Re: Address to Comments from the City of Mississauga
2121 Rathburn Road East – Environmental Noise Assessment
City of Mississauga, ON
VCL File: 1250230.000

RL\sk
L#1 - Addendum - 2121 Rathburn Road East, Mississauga - Address Comments from City V1_0.docx

Title	**Site Plan**
Project Name	**2121 Rathburn Road East, Mississauga**
Date	**April. 6, 2026**
Project No.	**1250230.000**
Figure	**1**

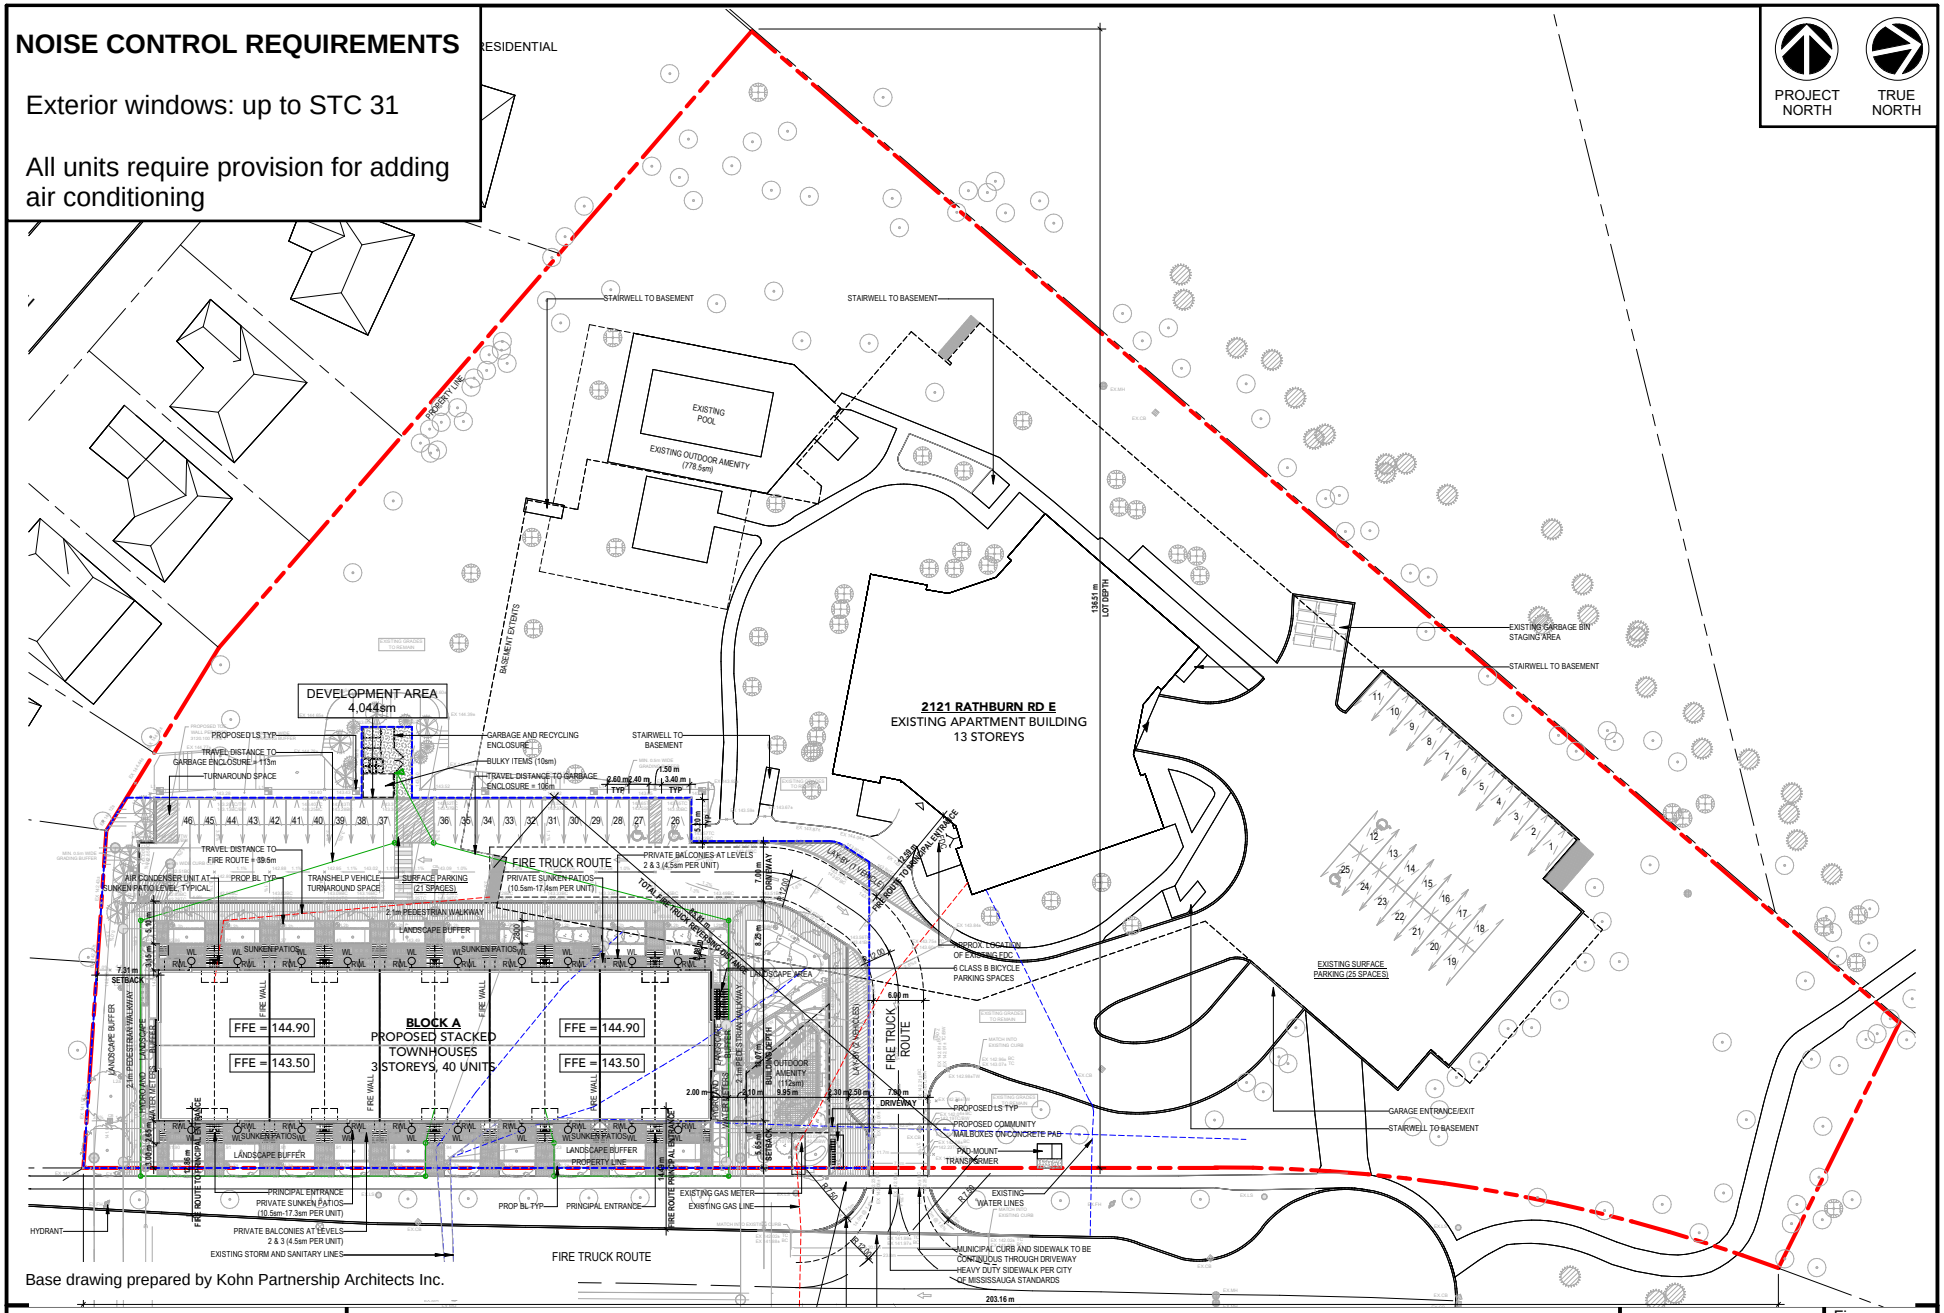
> *Transportation sources to be updated to include for aircraft noise as a noise source, as the site is situated within the Pearson International Airport noise exposure forecast (NEF) composite noise contour NEF 25 (Refer to City of Mississauga Official Plan section 6.10.2 Aircraft Noise).*

NOISE CONTROL REQUIREMENTS

Exterior windows: up to STC 31

All units require provision for adding air conditioning
